HISTORIC AND DESIGN REVIEW COMMISSION

October 18, 2023

HDRC CASE NO: 2023-396
ADDRESS: 1210 E ELMIRA ST
LEGAL DESCRIPTION: NCB 6796 BLK 8 LOT 1 THRU 3 & S IRR 124.65 OF 4-6 & S IRR 42.09 FT OF 7
ZONING: IDZ, RIO-2
CITY COUNCIL DIST.: 1
APPLICANT: Daniel Elder/OXBOW REAL ESTATE LLC
OWNER: Daniel Elder/OXBOW REAL ESTATE LLC
TYPE OF WORK: Construction of a 6-story residential structure
APPLICATION RECEIVED: September 29, 2023
60-DAY REVIEW: November 28, 2023
CASE MANAGER: Edward Hall

Coopers Row North
HDRC Conceptual Approval
Narrative

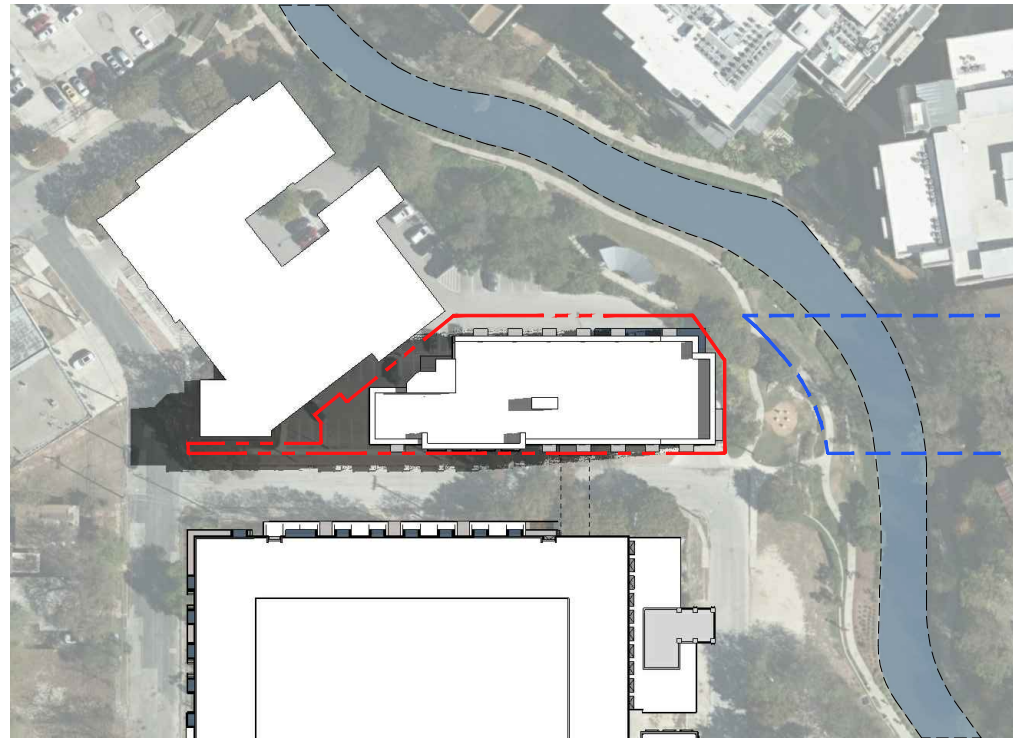
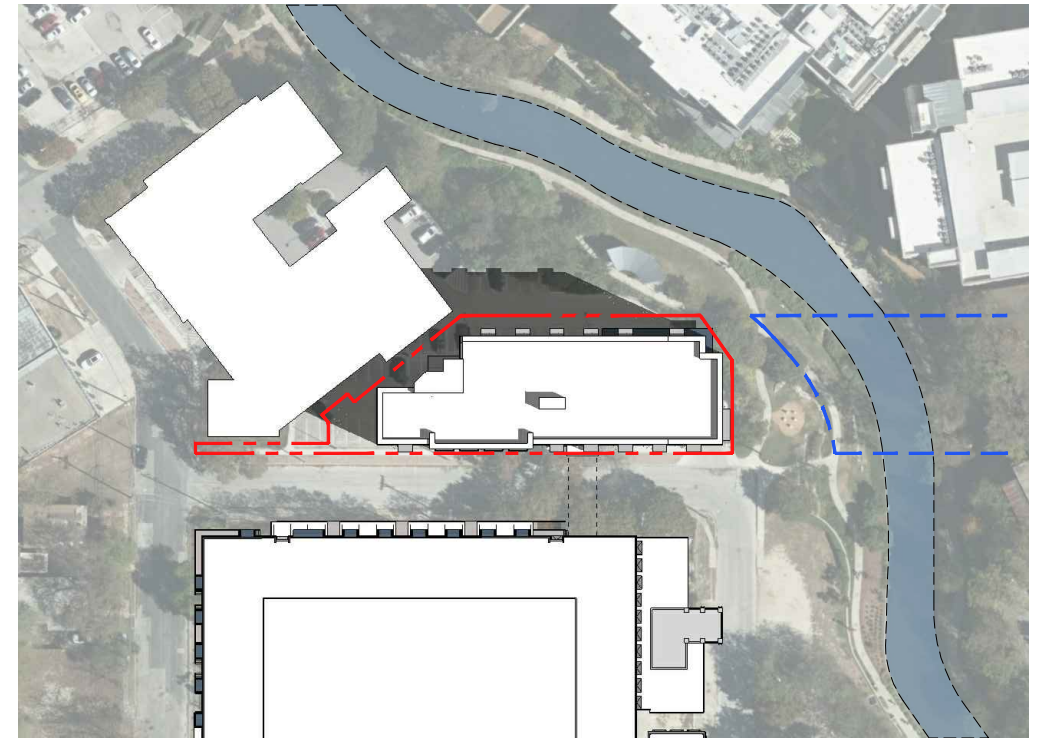
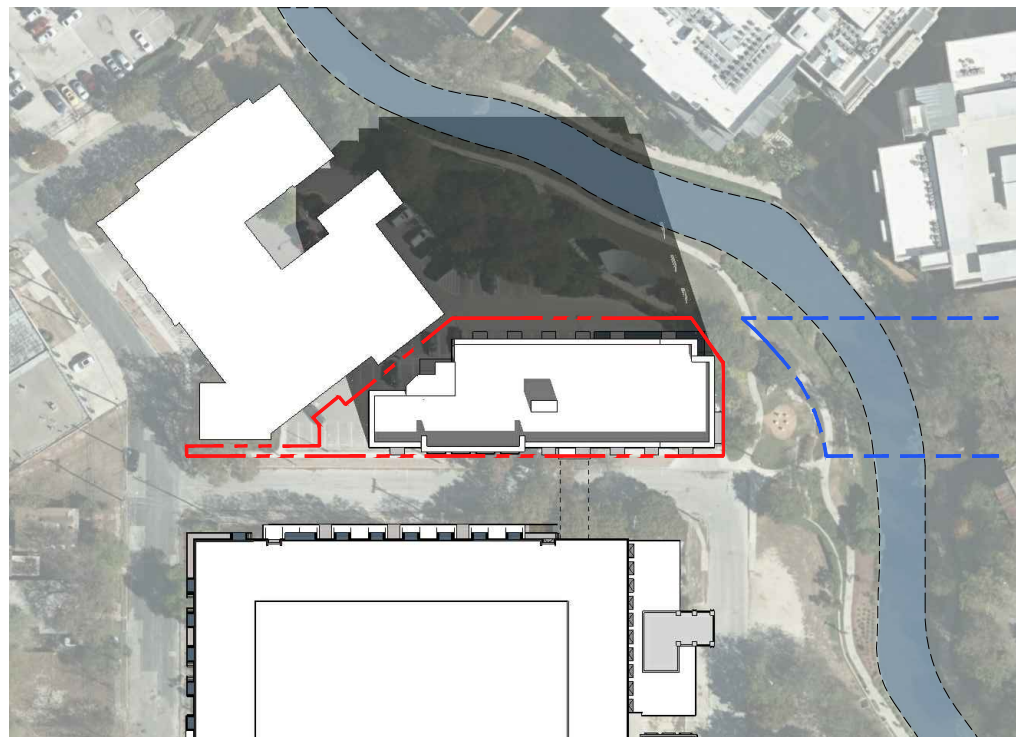
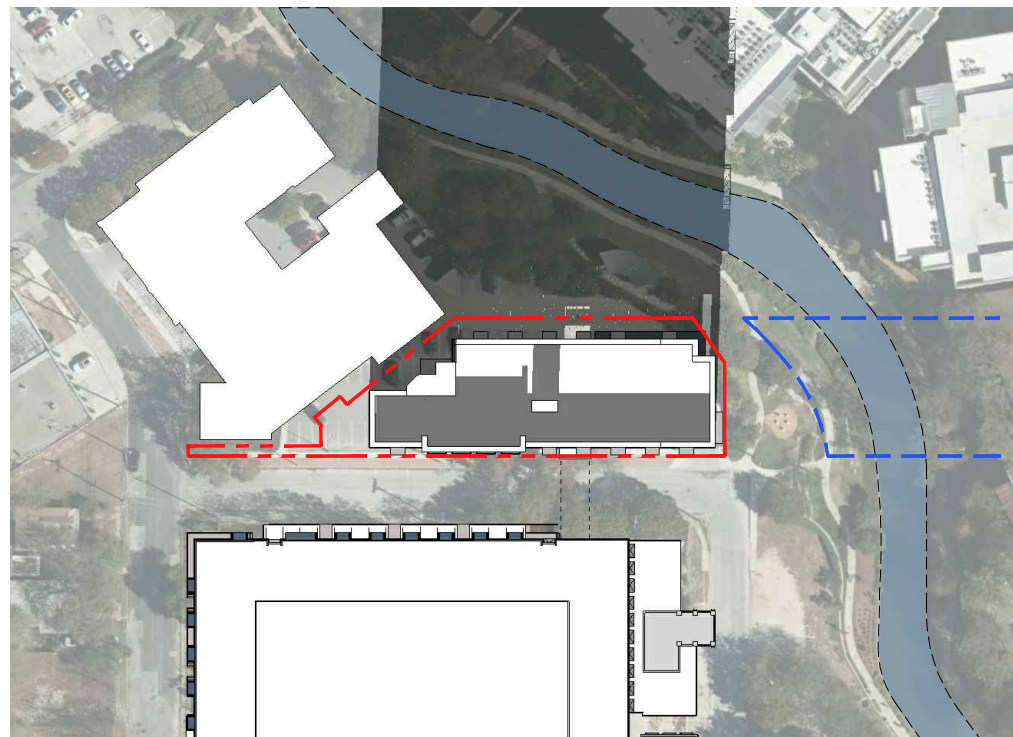
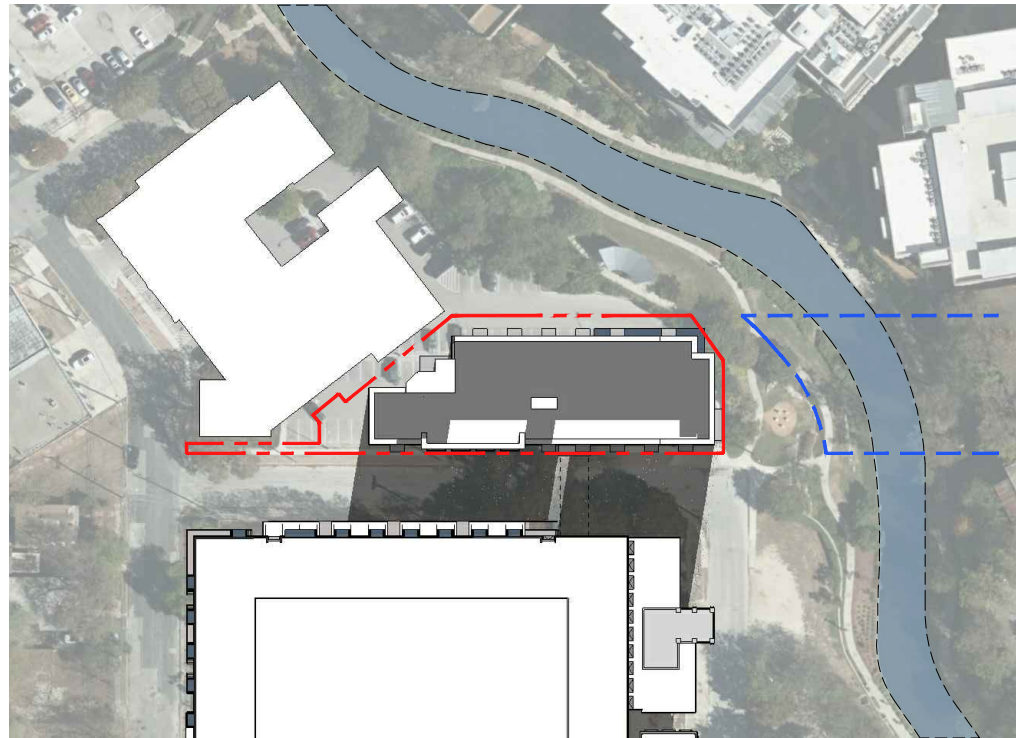
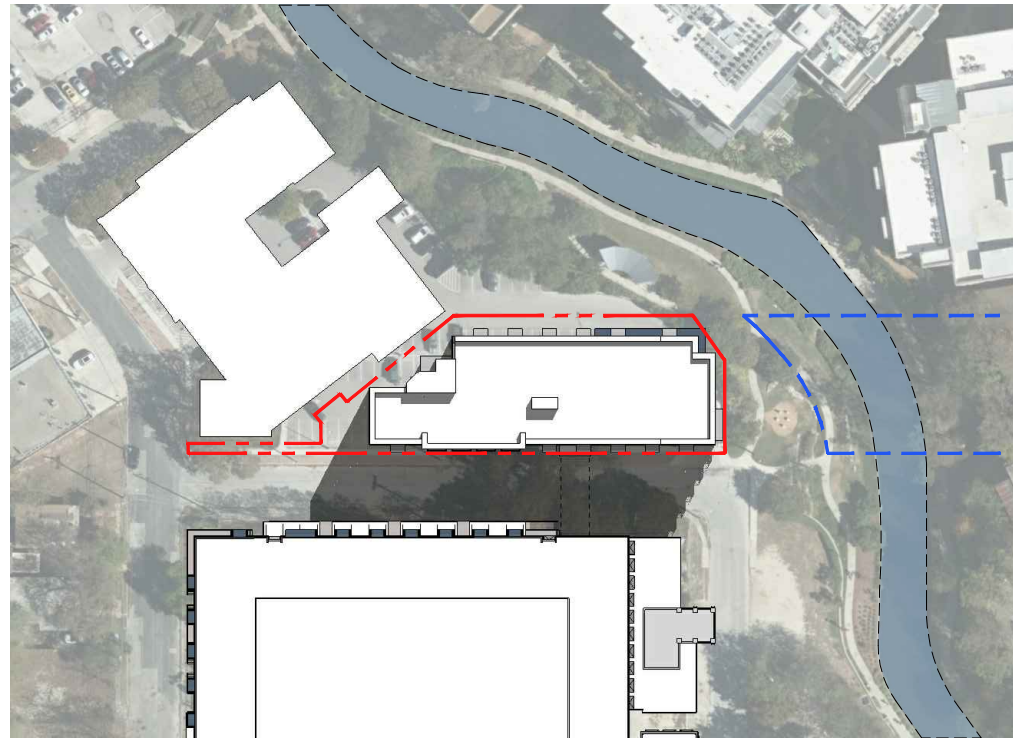
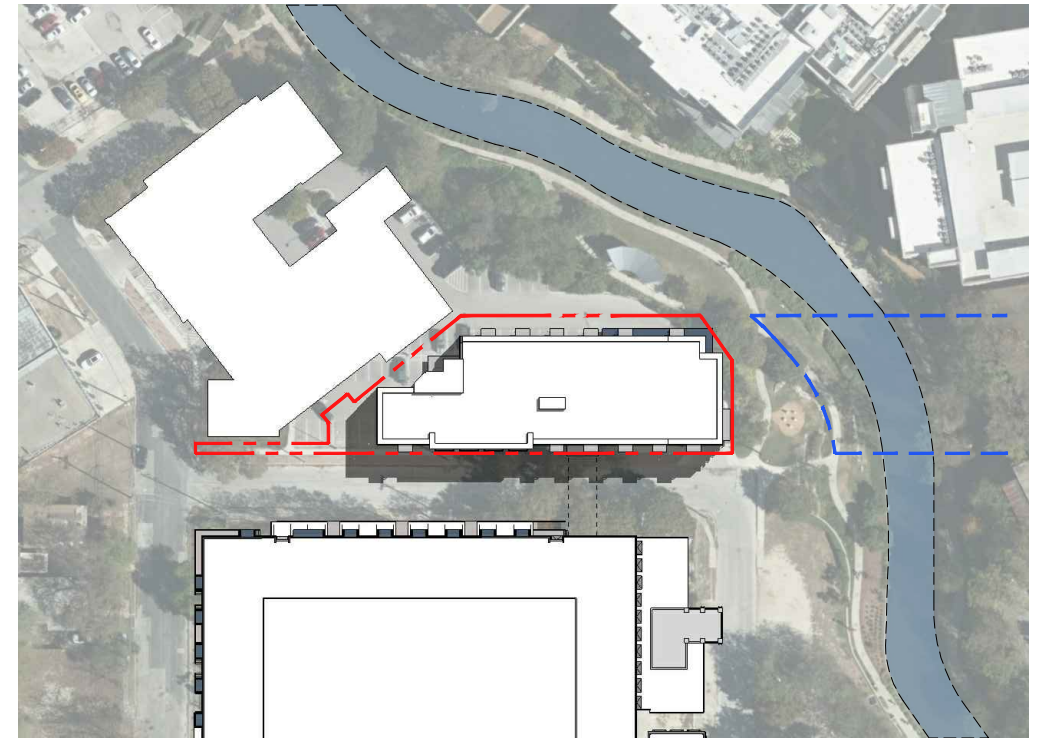
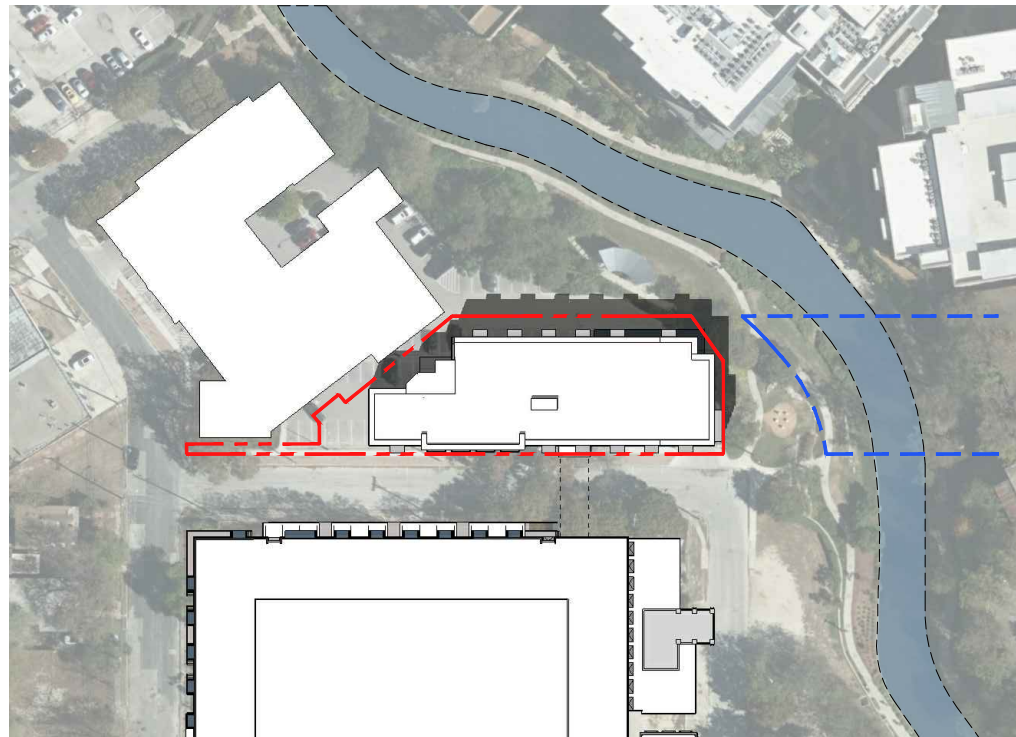
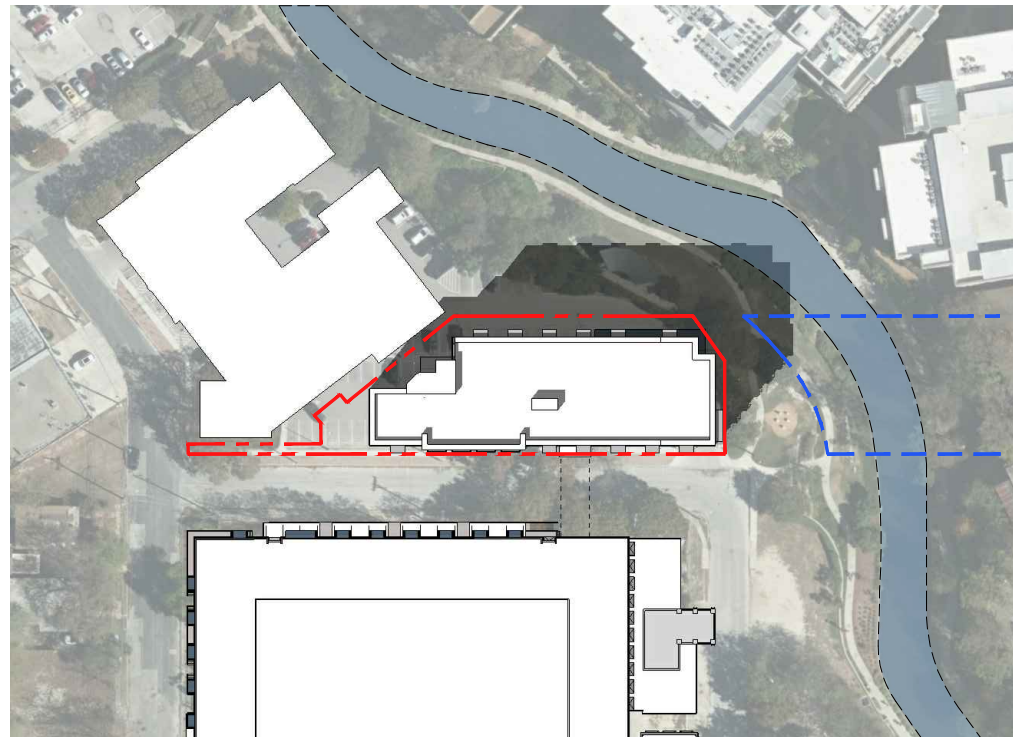
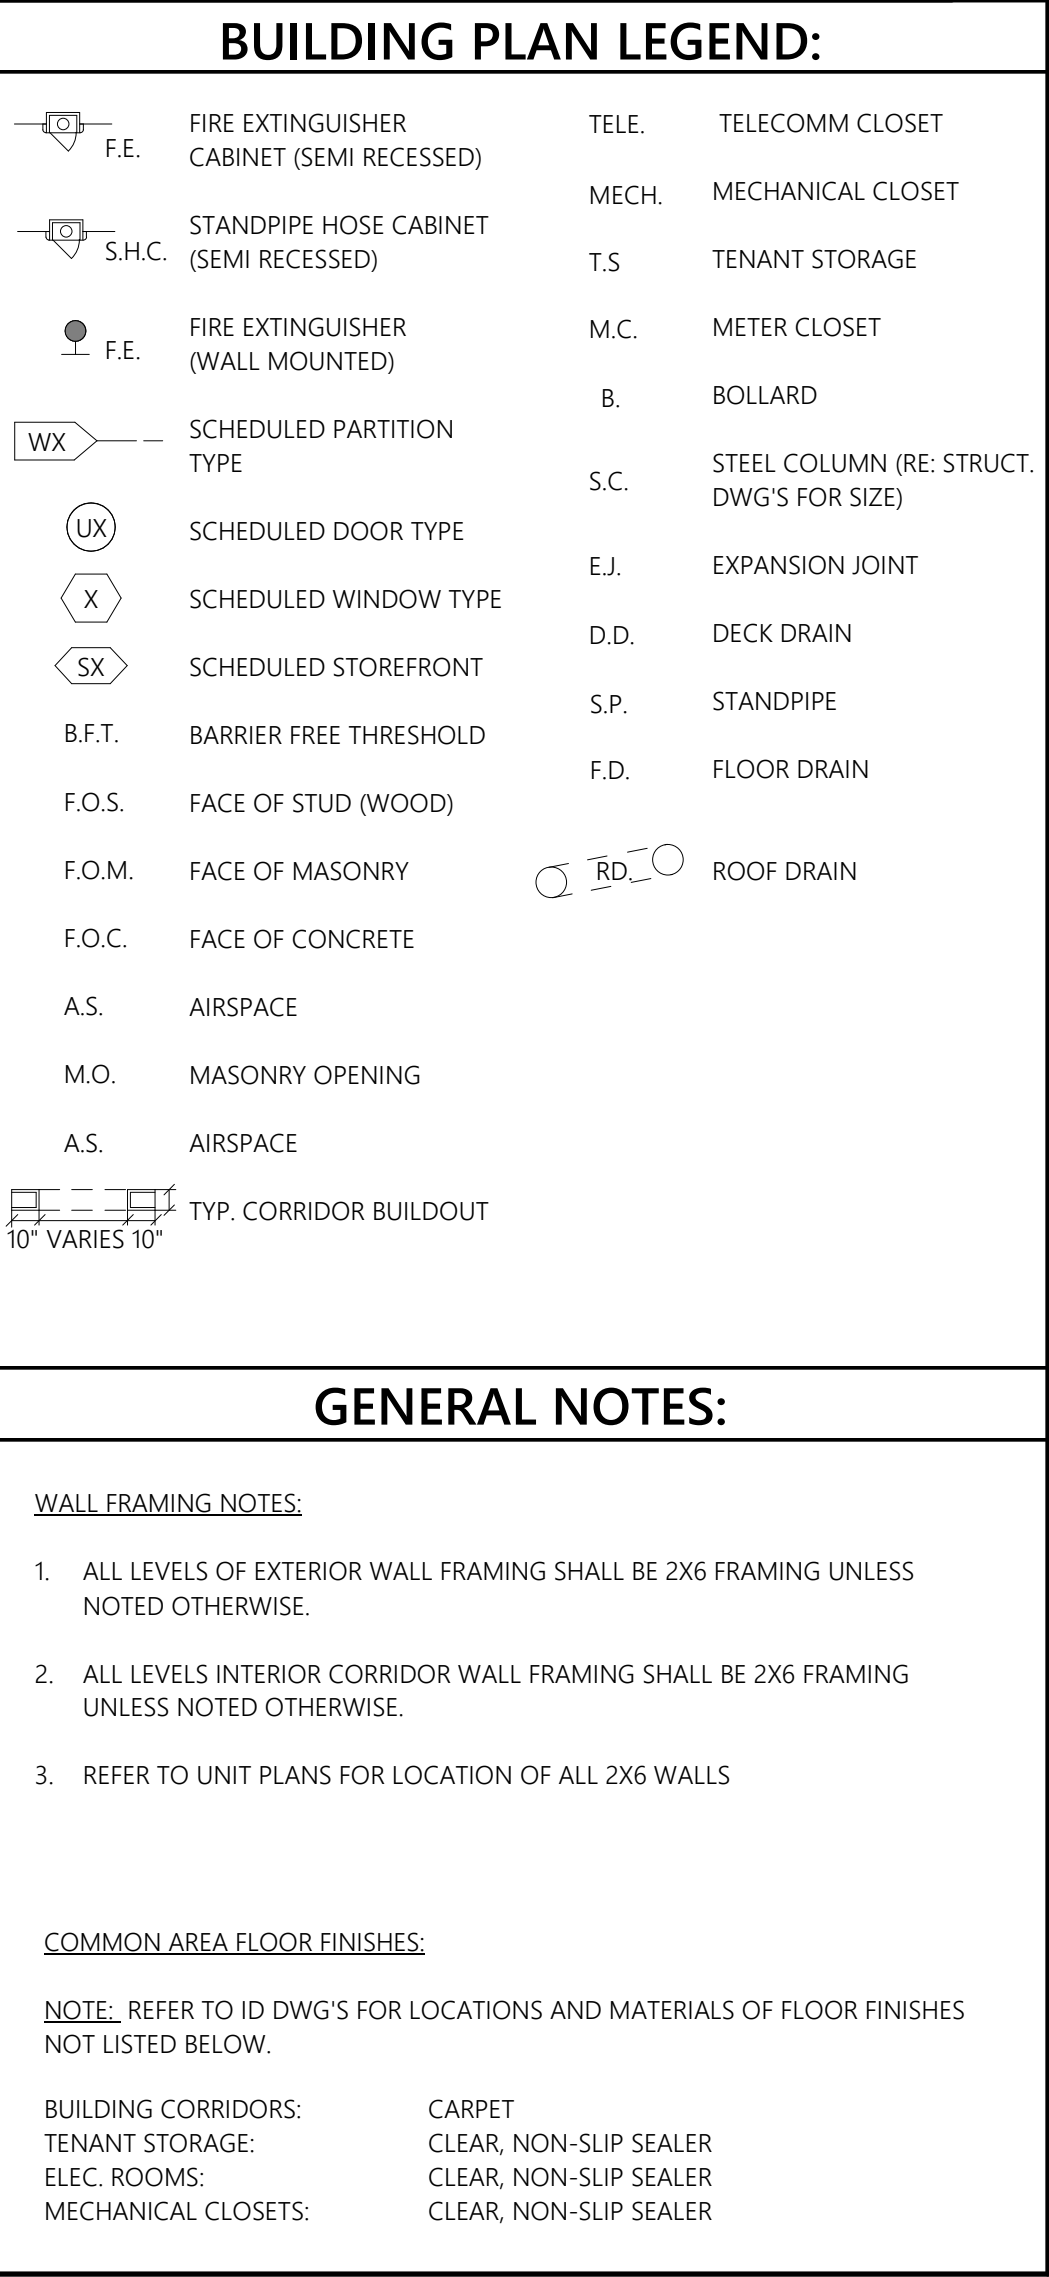
- e. **SOLAR ACCESS** – The UDC Section 35-673(a)(1) provides guidelines for solar access to the San Antonio River regarding new construction. The applicant has provided a solar study noting compliance with the UDC.
